Serial No.: 09/687,886

For: METHODS AND APPARATUS FOR ROTOR
OVER-SPEED PROTECTION

AMENDMENT AFTER FINAL

FIG. 4

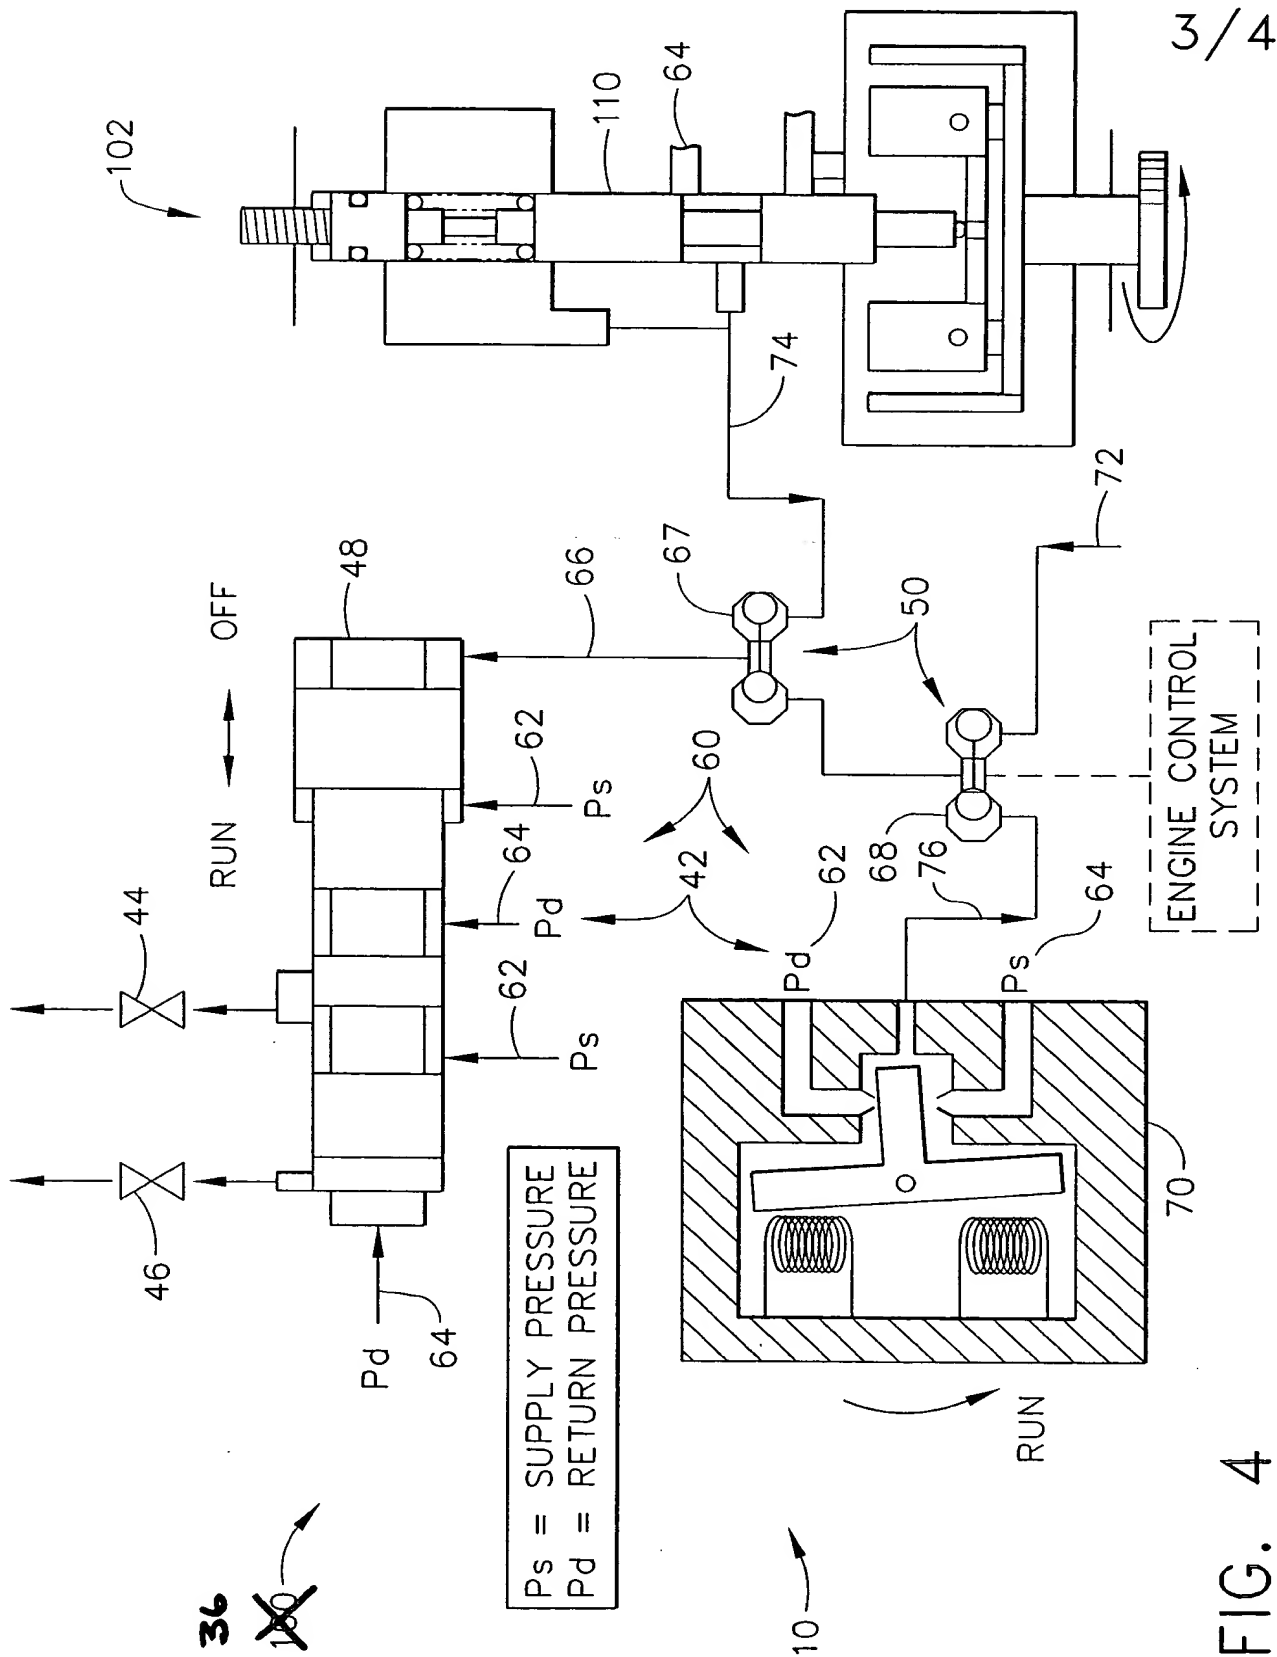
The objection to the drawings under 37 C.F.R. 1.83(a) is respectfully traversed. Submitted herewith is a Request for Approval of Drawing Changes. Specifically, Figures 4 and 5 have each been amended to delete references to numerals 100 and 200, and to each identify the fuel system interface with reference numeral 36. Upon approval of the drawing changes, Applicant will submit substitute formal drawings incorporating the above-noted change. No new matter has been added. For the reasons set forth above, Applicant respectfully requests the objection to the drawings be withdrawn.
